DATE: 08.12.2019
TO: ProTrak
FROM: Mitesh Baxi
Traffic Engineering

■ **MAIDES PARK GYMNASIUM ADDITION [TRC Plan Review #2]**

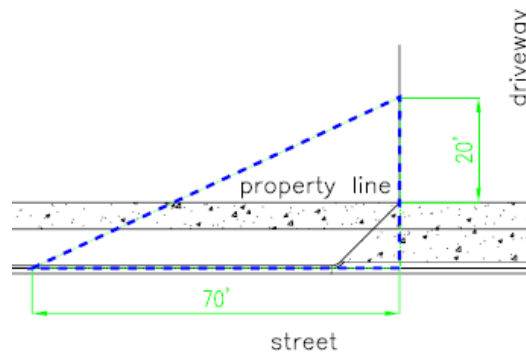
1. The City's 20'x70' sight distance triangle is not implemented correctly. Please revise as per below image. [Sec.18-529(c) (3) CofW LDC] [Sec. 18-812 CofW LDC].
